Subject: Emergency Order Issued - Community Within the Corridor Limited Partnership

MEMORANDUM

SUBJECT : Response to Emergency Order for Community Within the Corridor East Block
BRRTS # 02-41-263675

Exhibit B
Specifications for 7.5 HP Blower

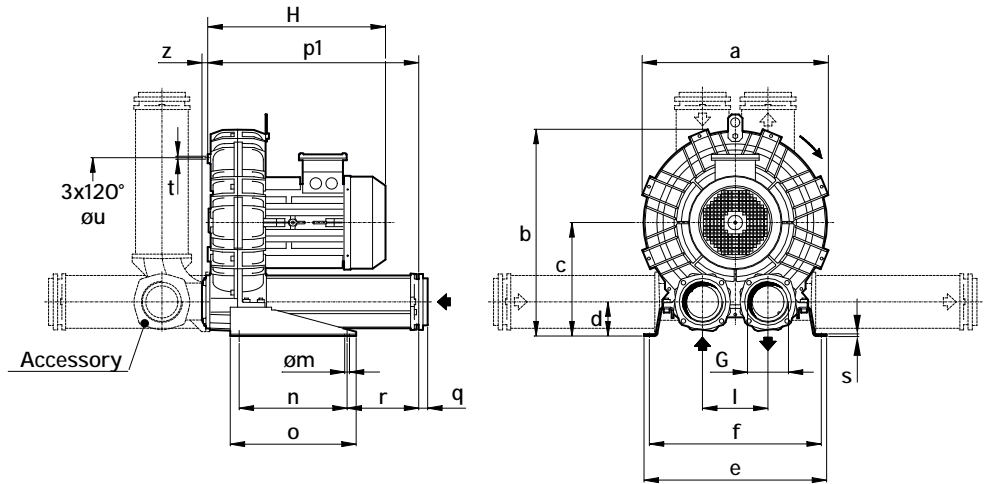
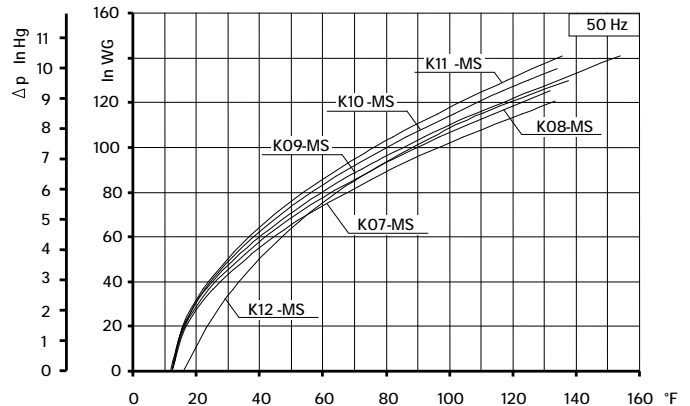
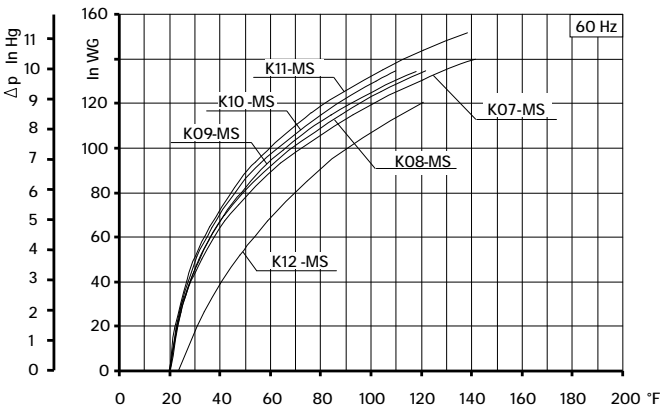
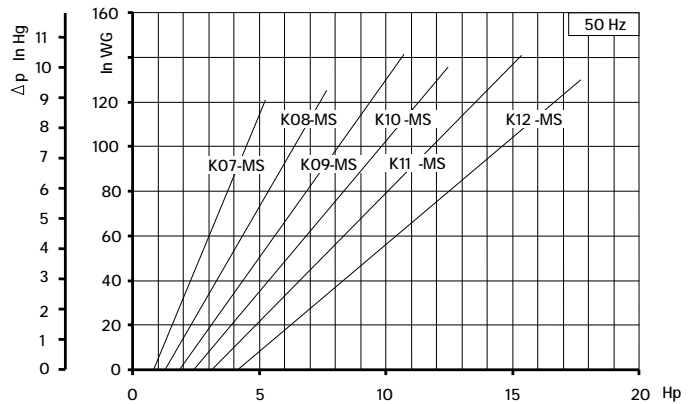
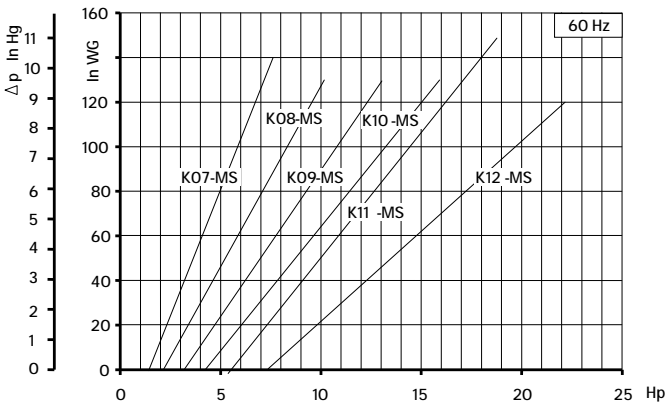
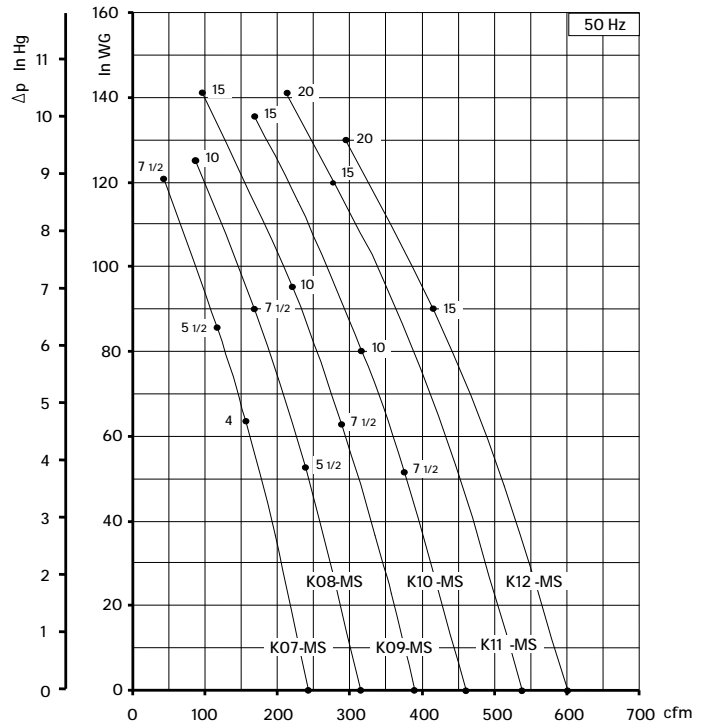
- *Specification of fan-types, sizes, and locations. Clarify the terms “fan” versus “blower” and whether they indicate the same system component. Specifically clarify the use of “7.5 HP blowers”, as discussed in the 03/31/23 daily summary report, and where these were installed.*

In the documentation for East Block vapor mitigation system, the term “fans” refers to individual point systems, while the term “blower” refers to the sub-slab vapor depressurization piping network.

A 7.5HP blower was connected to the northern system, and a 7.5 HP blower was connected to the southern system. More particularly, please see Exhibit B for specifications pertaining to the 7.5 HP blowers that were installed as a modification to the original design of the vapor mitigation system.

Figure 1
Typical Cross Section of Vapor Mitigation Trench

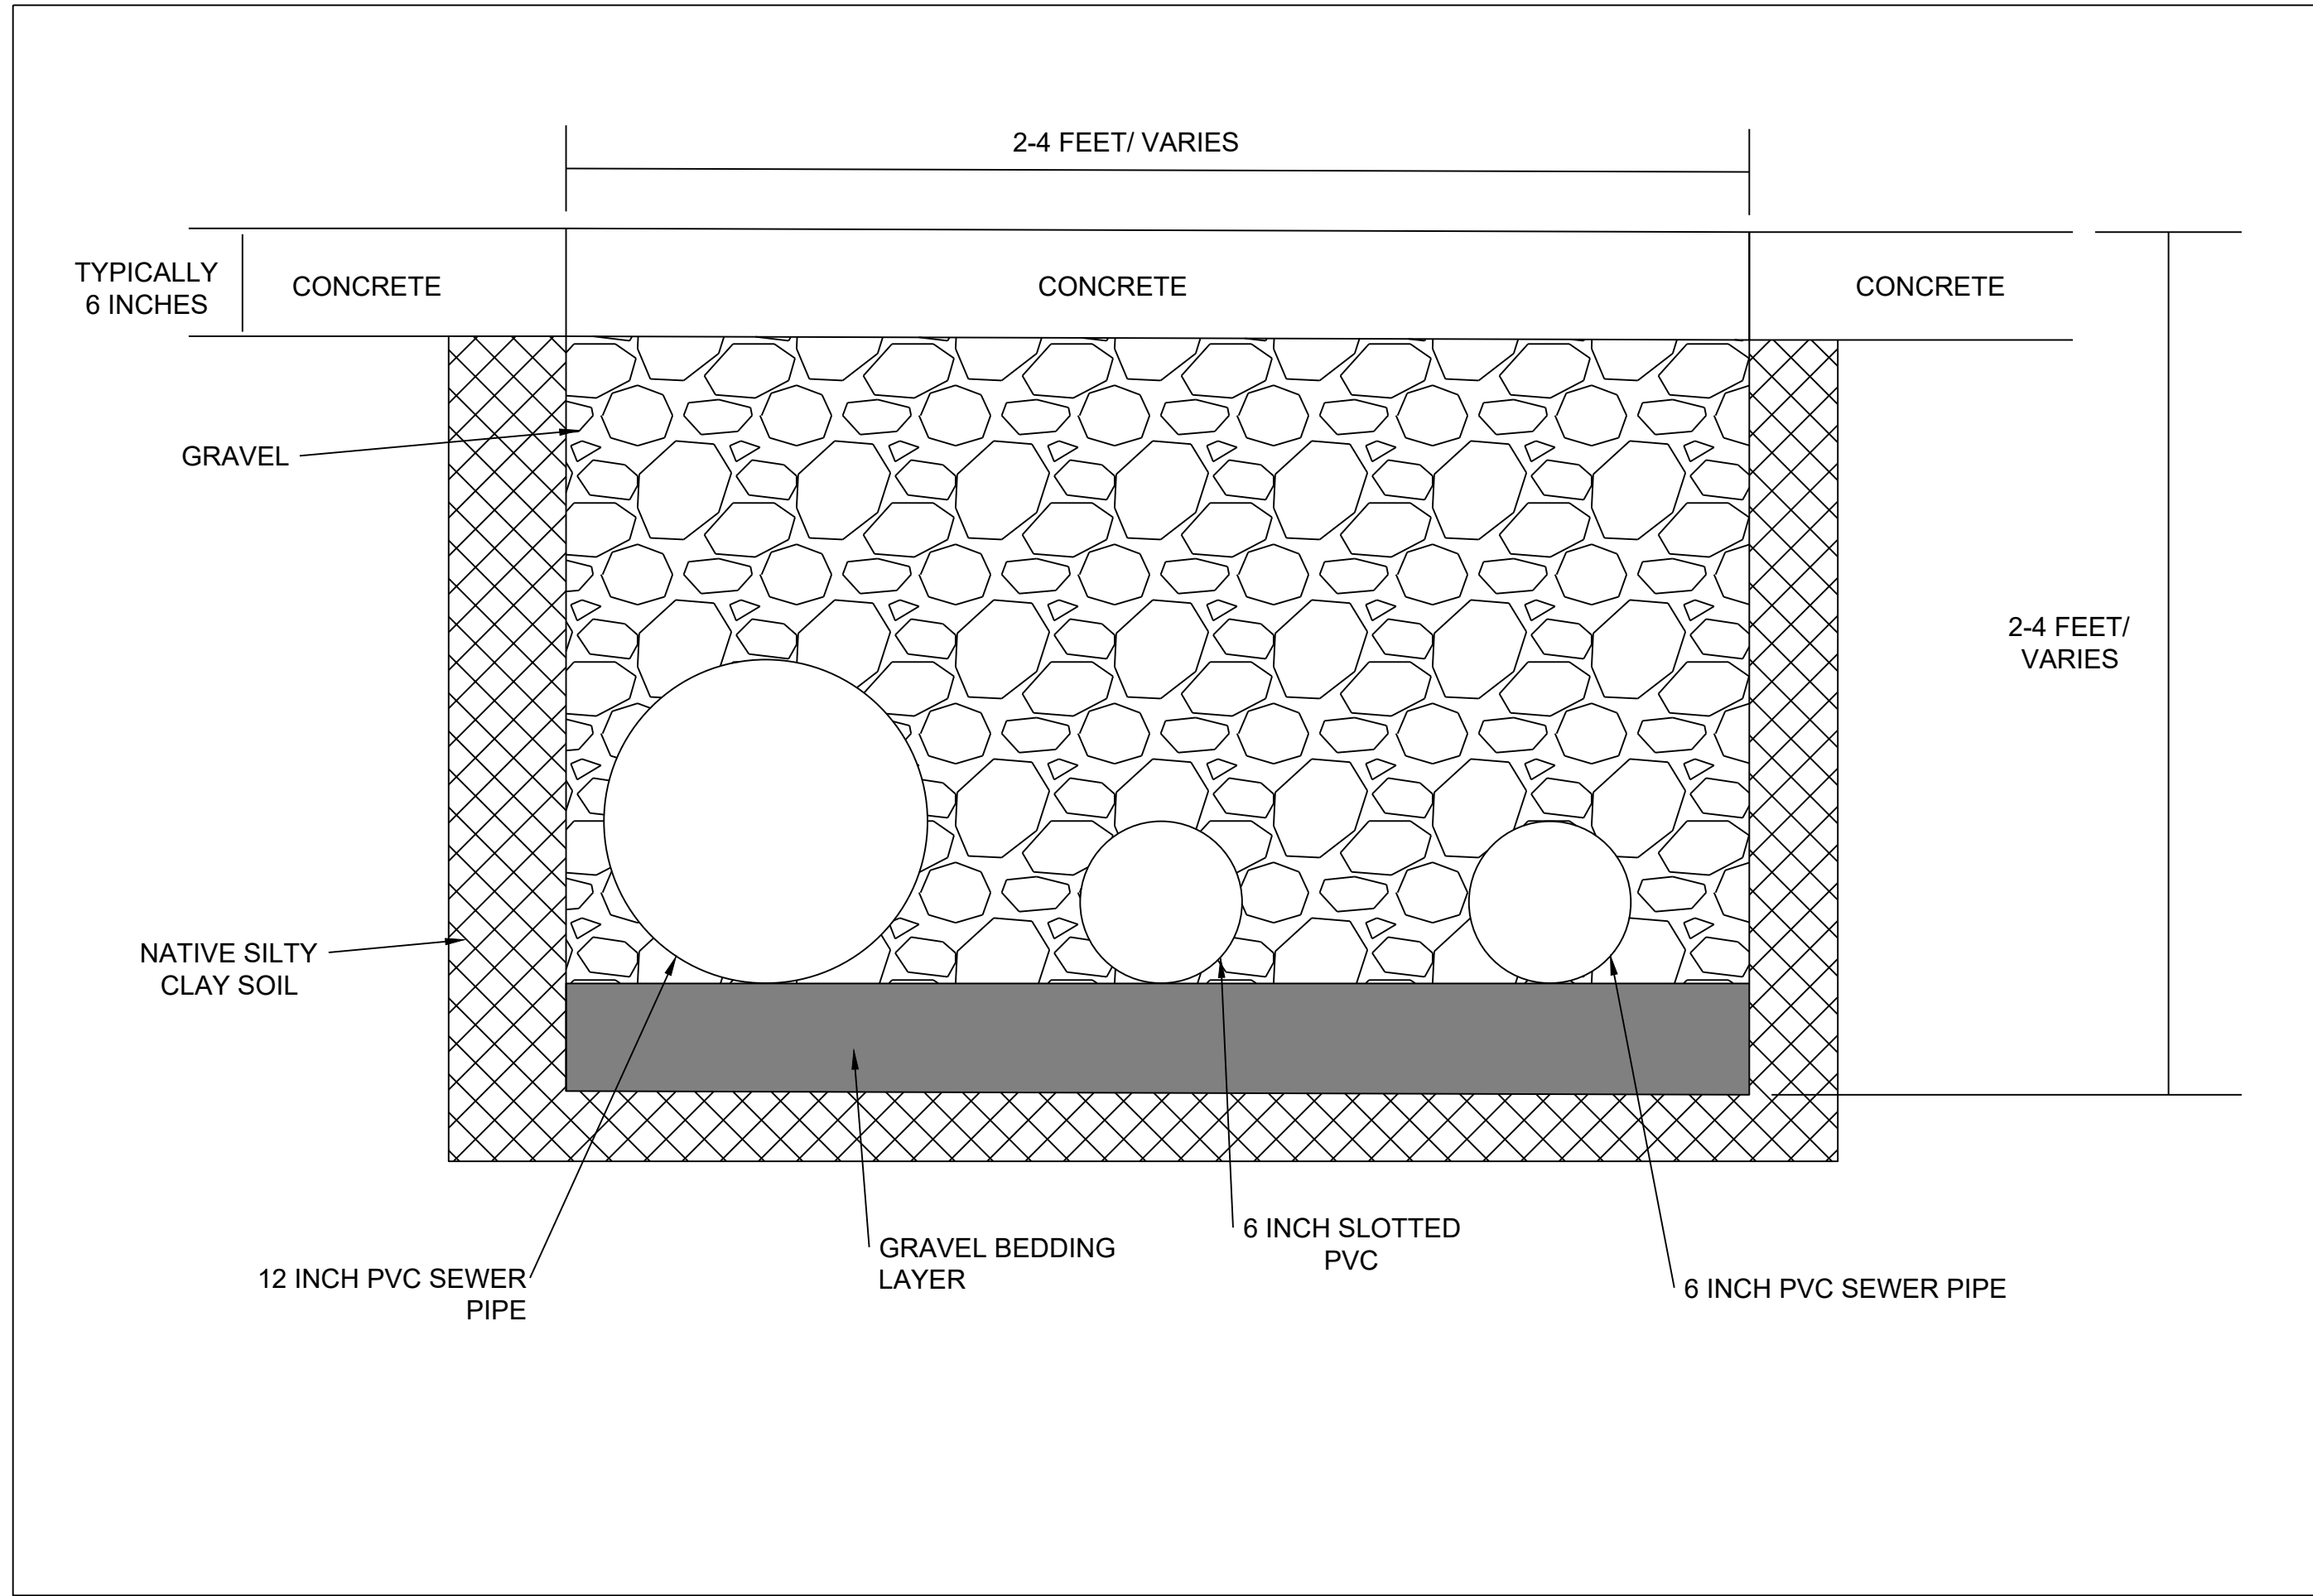
- *As-built maps, plan sheets, drawings, isometric drawings, and cross-sections. Specifically provide cross-sections of the vapor mitigation system as it was built, including scale to highlight depth at which the system was installed. Specifically provide a N-S and E-W cross-section through the western area of Building 1B to show the system relationship to the excavation areas and other relevant subsurface features (i.e., groundwater depth, other utilities, soil type, etc.).*

Isometric drawings are not typically prepared for sub-slab de-pressurization systems. A typical cross section of the vapor mitigation trench is attached in Figure 1.

The monitoring well in the gym shows that groundwater under the building is between 19 and 25 feet below ground surface. Portions of the system share a trench with the plumbing. Soil types surrounding the trench are typically silty clay.

The trench is approximately 2 to 4 feet wide and approximately 2 to 4 feet deep, and is filled with gravel. The variation is attributed to multiple utilities needing to fit in the same trench and pitch required for gravity flow.
